Mod2018/0180

project:
**LOT 74 D.P.8075
77 BOWER STREET MANLY**

drawing:
ELEVATION NORTH & EAST
status:
SECTION 96 MODIFICATION TO DA269/2015

NORTH ELEVATION

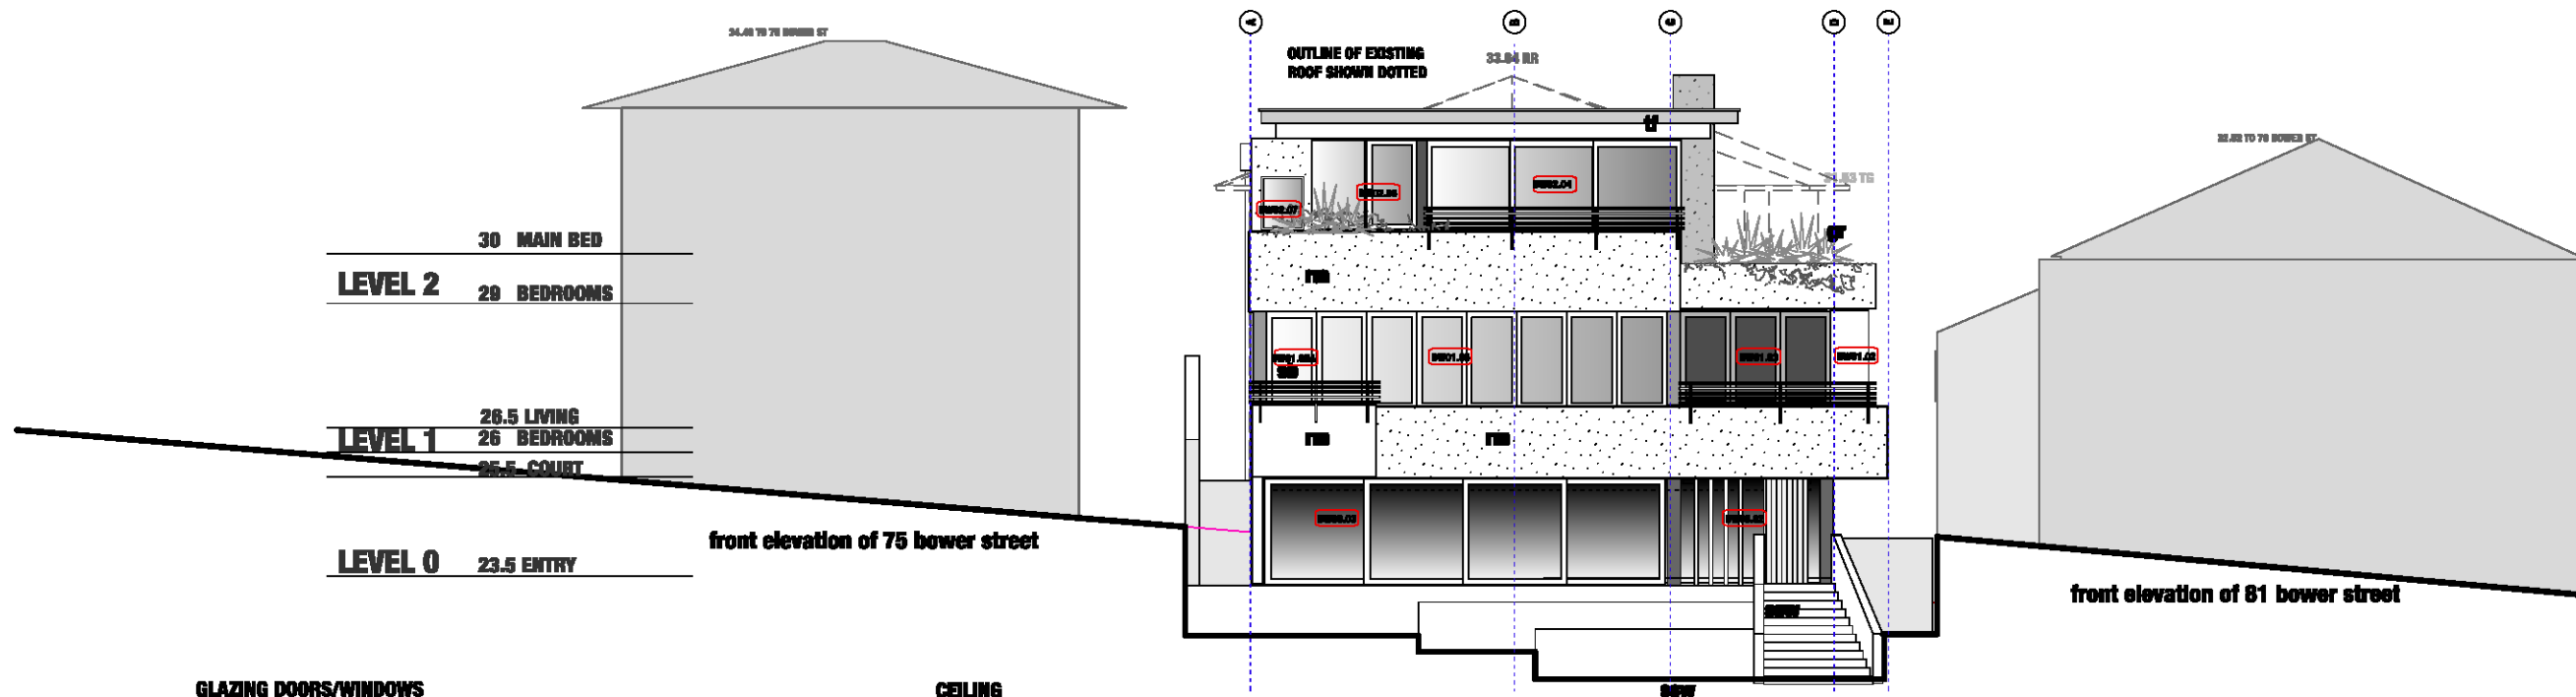
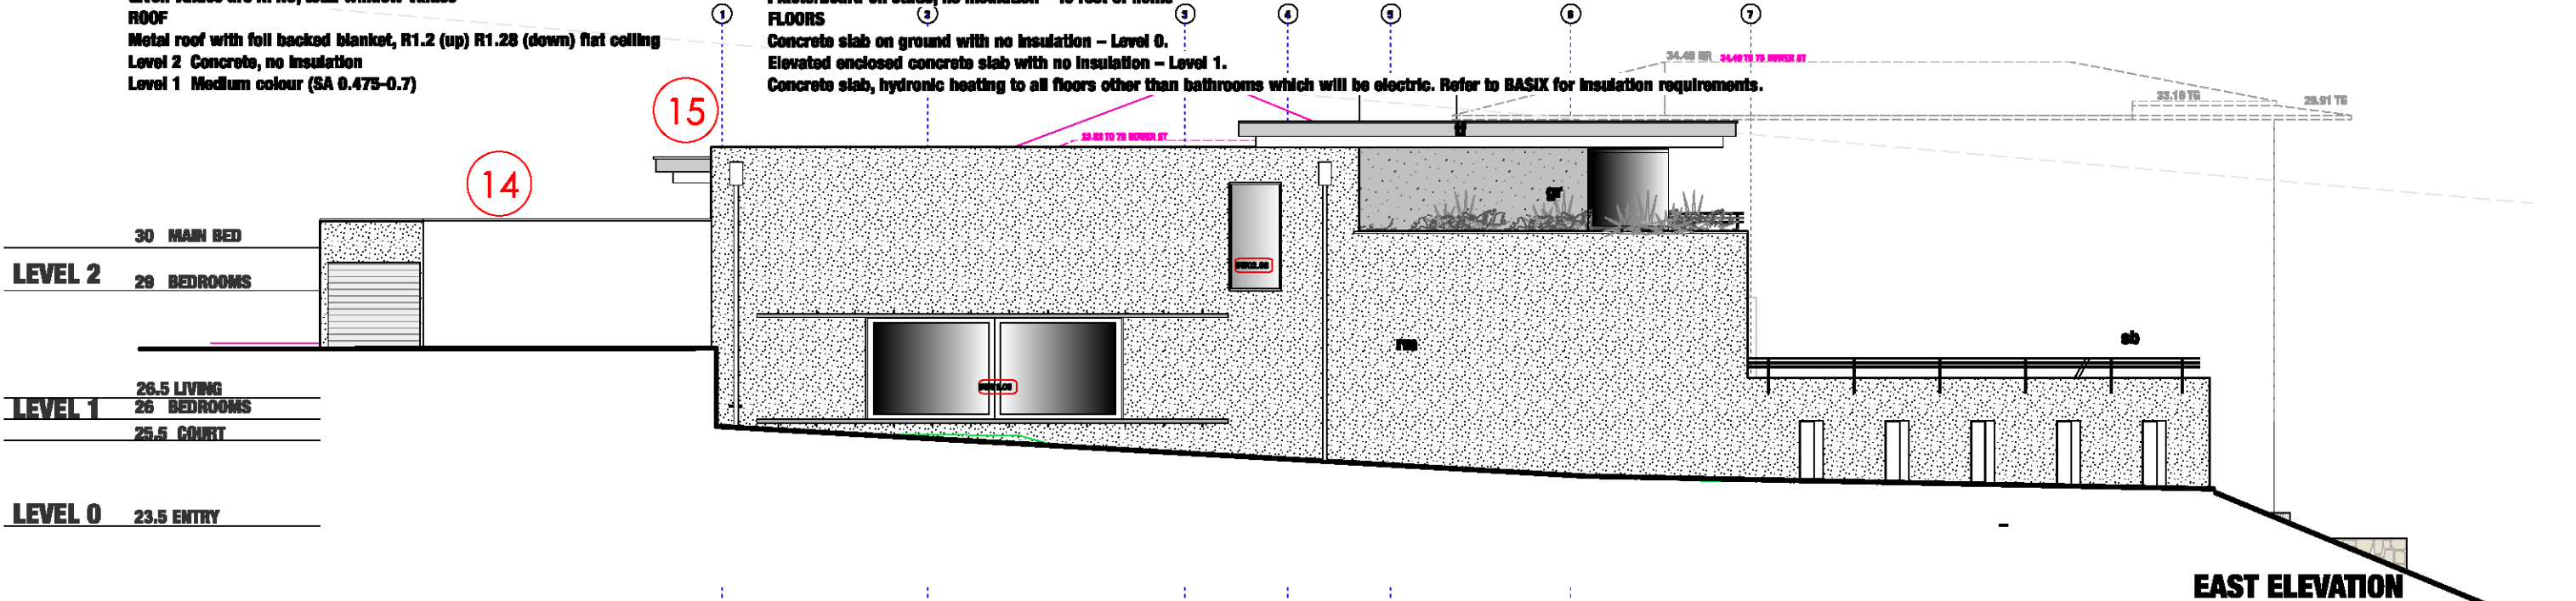
1. SWIMMING POOL ADJUSTED.
2. INTERNAL STAIR RECONFIGURED.
3. SERVICE AREA RECONFIGURED.
4. GYM RECONFIGURED.
5. LIGHTWELL/VOID.
6. ENSUITE RECONFIGURED.
7. TREE TO BE REMOVED.
8. POWDER ROOM RELOCATED.
9. BATHROOM RELOCATED.
10. FLOOR LEVEL ADJUSTED RL 25.3 TO RL 26.0
11. LAUNDRY/CELLAR RECONFIGURED.
12. ENTRY/STAIR RECONFIGURED.
13. MAIN ENSUITE RECONFIGURED.
14. GARAGE PARAPET.
15. BW DELETED LIFT OVERUN.

SOUTH ELEVATION

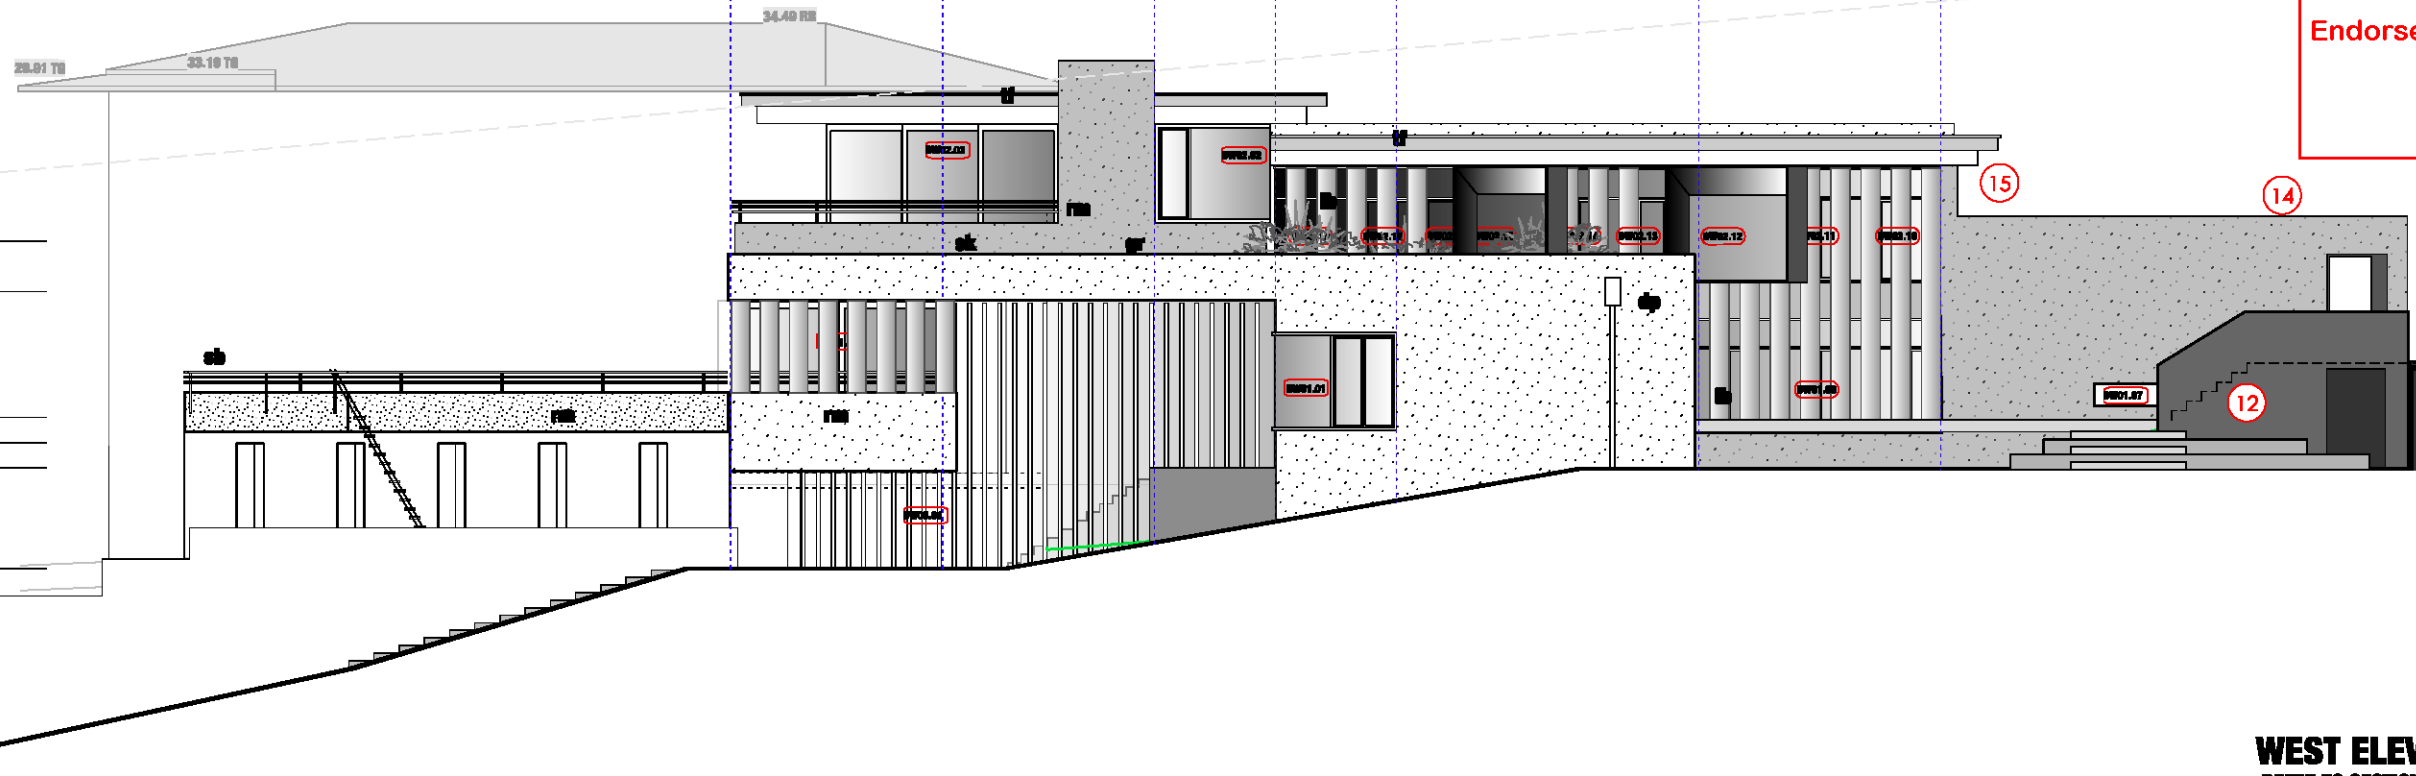
- SECTION 96 MODIFICATION TO DA289/2015:**
1. SWIMMING POOL ADJUSTED.
 2. INTERNAL STAIR RECONFIGURED.
 3. SERVICE AREA RECONFIGURED.
 4. GYM RECONFIGURED.
 5. LIGHTWELL/VOID.
 6. ENSUITE RECONFIGURED.
 7. TREE TO BE REMOVED.
 8. POWDER ROOM RELOCATED.
 9. BATHROOM RELOCATED.
 10. FLOOR LEVEL ADJUSTED RL 25.5 TO RL 26.0
 11. LAUNDRY/CELLAR RECONFIGURED.
 12. ENTRY/STAIR RECONFIGURED.
 13. MAIN ENSUITE RECONFIGURED.
 14. GARAGE PARAPET.
 15. RW DELETED LEFT OVERLAP.

WEST ELEVATION
 REFER TO SECTION 01 FOR
 WINDOW NUMBERS

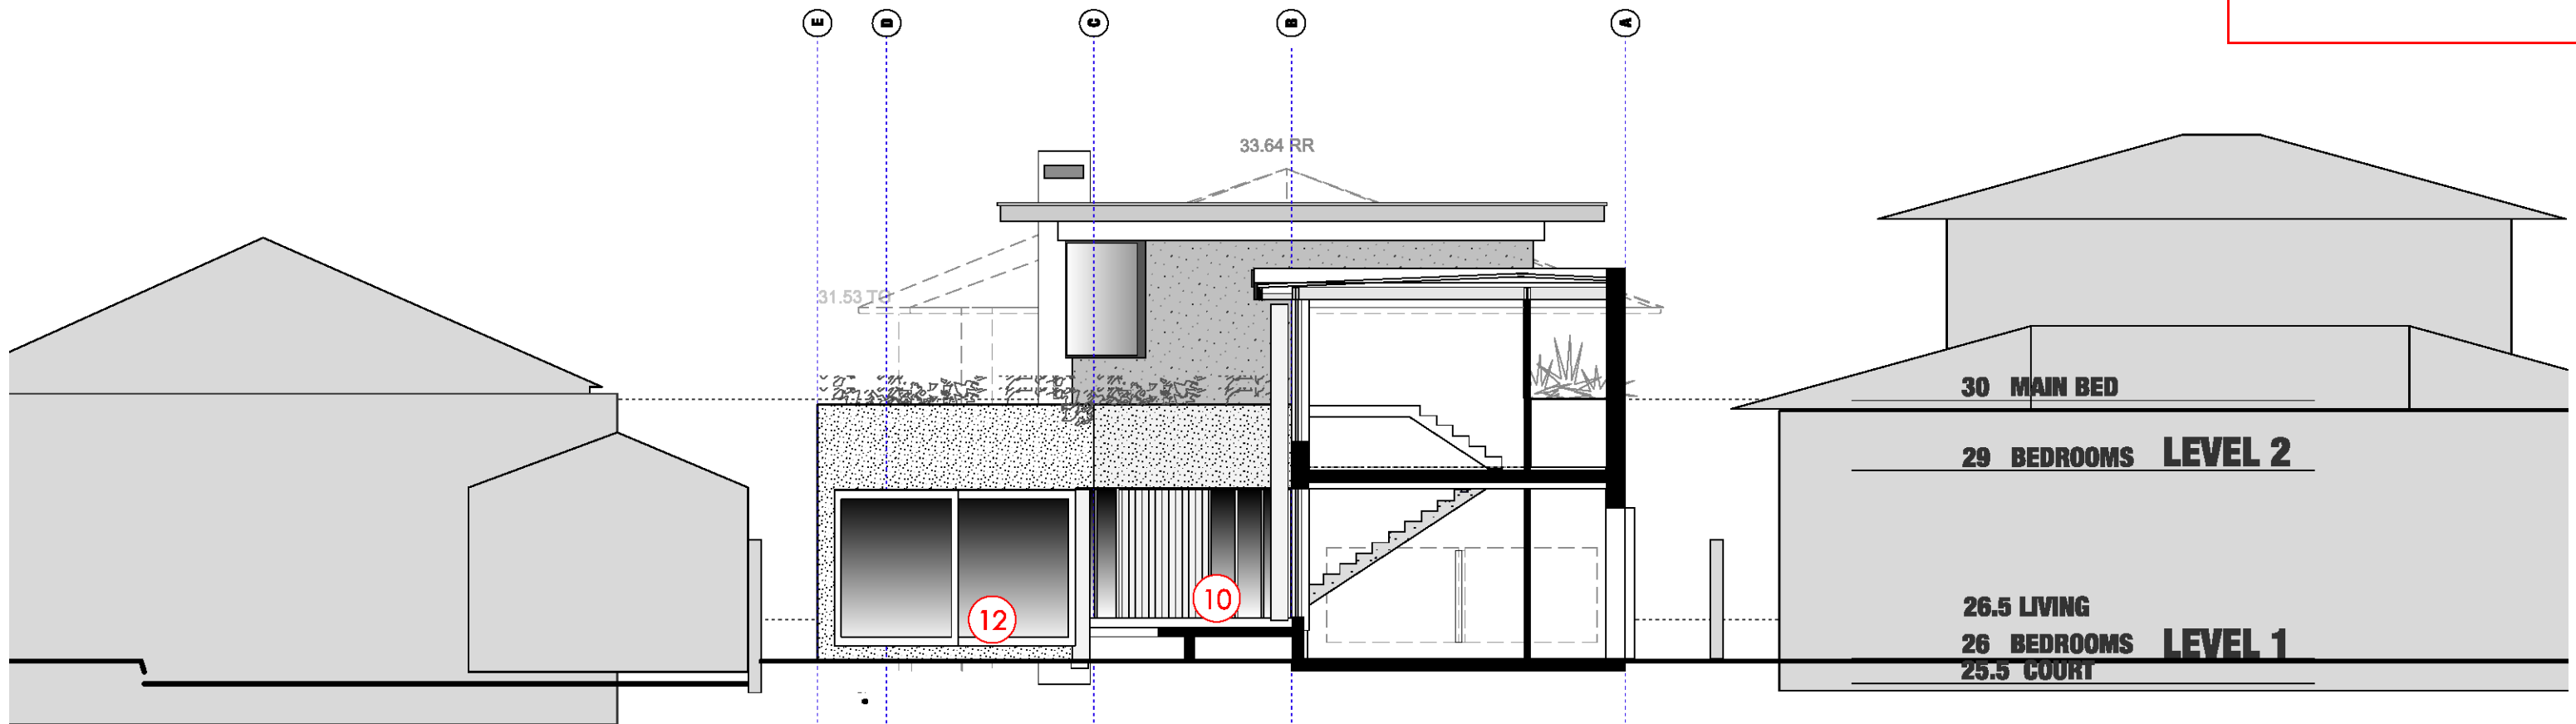
1. SWIMMING POOL ADJUSTED.
2. INTERNAL STAIR RECONFIGURED.
3. SERVICE AREA RECONFIGURED.
4. GYM RECONFIGURED.
5. LIGHTWELL/VOID.
6. ENSUITE RECONFIGURED.
7. TREE TO BE REMOVED.
8. POWDER ROOM RELOCATED.
9. BATHROOM RELOCATED.
10. FLOOR LEVEL ADJUSTED RL 25.5 TO RL 26.0
11. LAUNDRY/CELLAR RECONFIGURED.
12. ENTRY/STAIR RECONFIGURED.
13. MAIN ENSUITE RECONFIGURED.
14. GARAGE PARAPET.
15. BW DELETED LIFT OVERUN.
